ADDENDUM TO THE CONTRACT

MVWWTP ROOF REPLACEMENT

Contract No. BE19-205

ADDENDUM NO.: ONE

SHEET #
A3.2

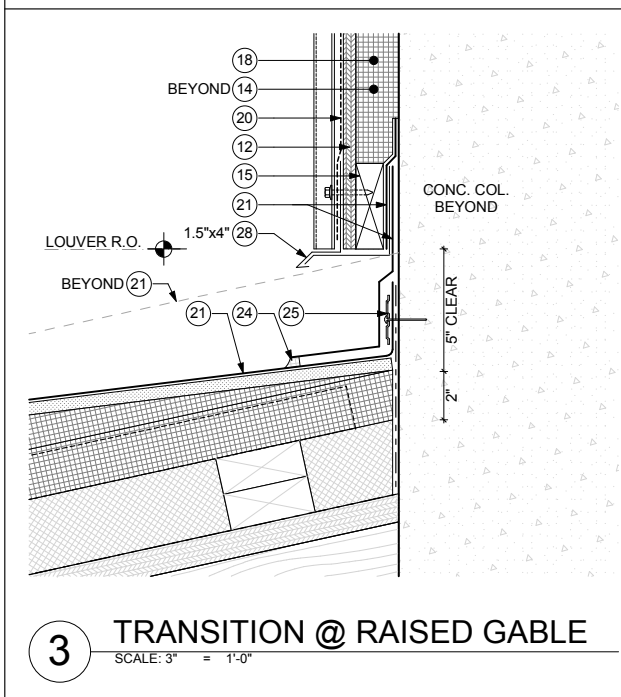
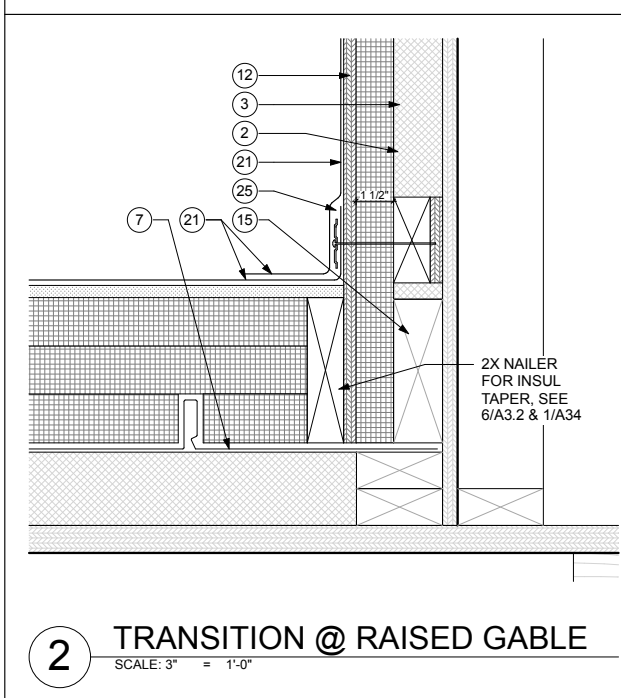
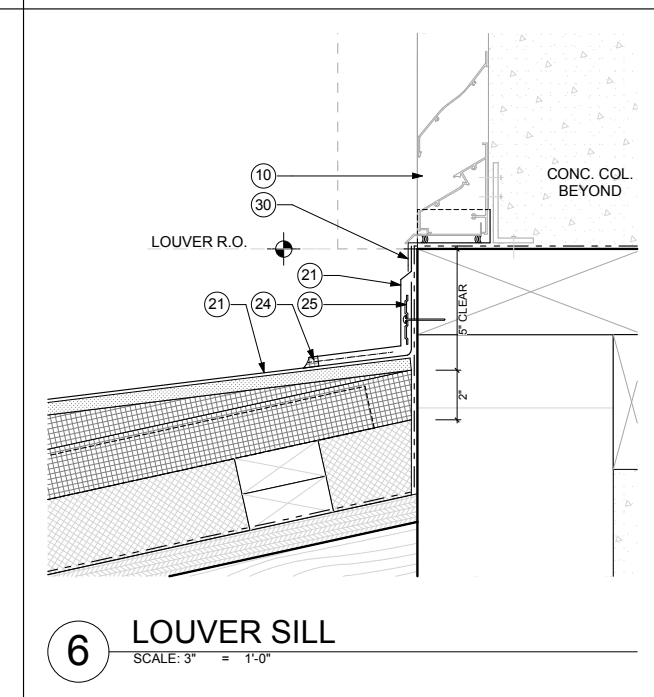
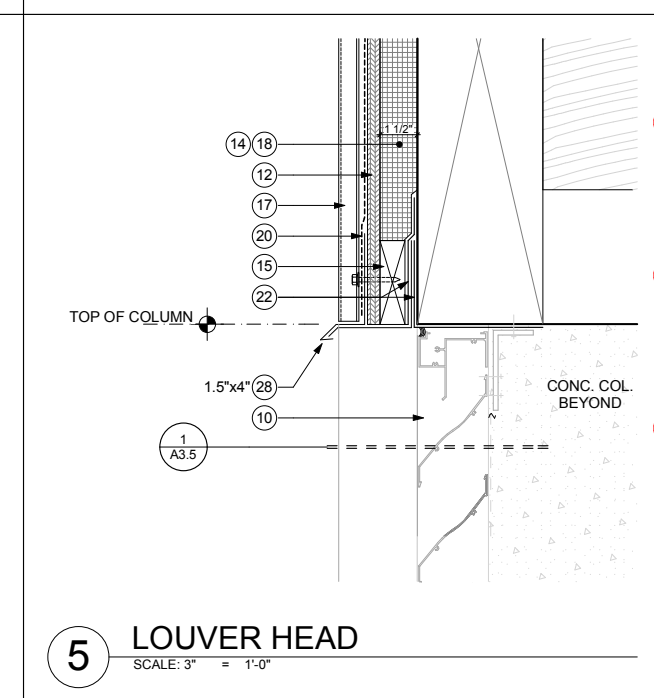
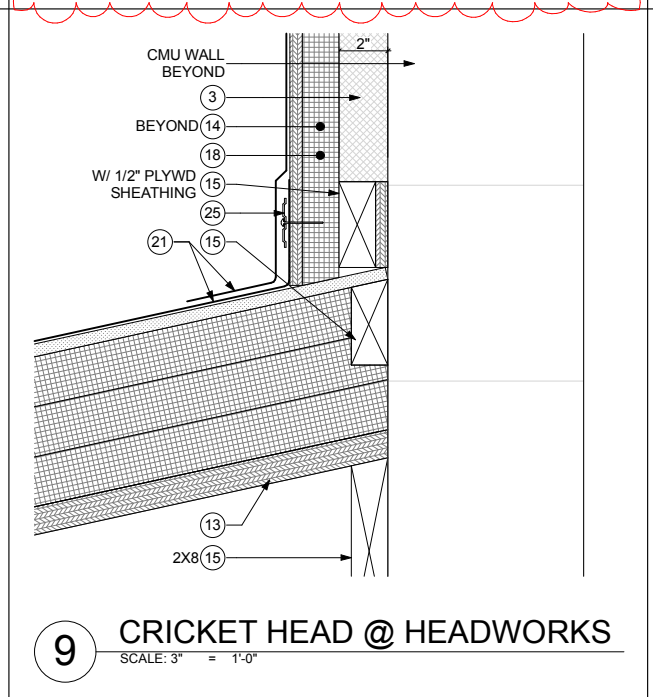
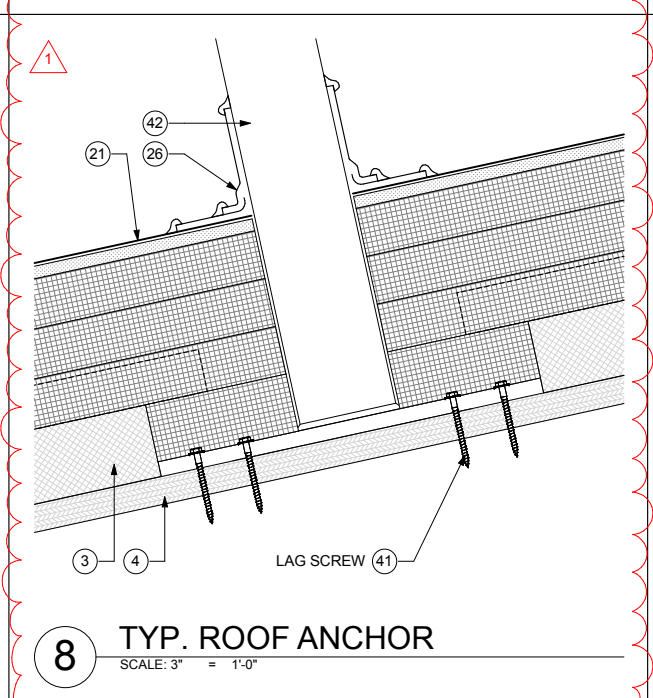
- Item No. 1 **Replace** SHEET A3.2 with the attached SHEET A3.2
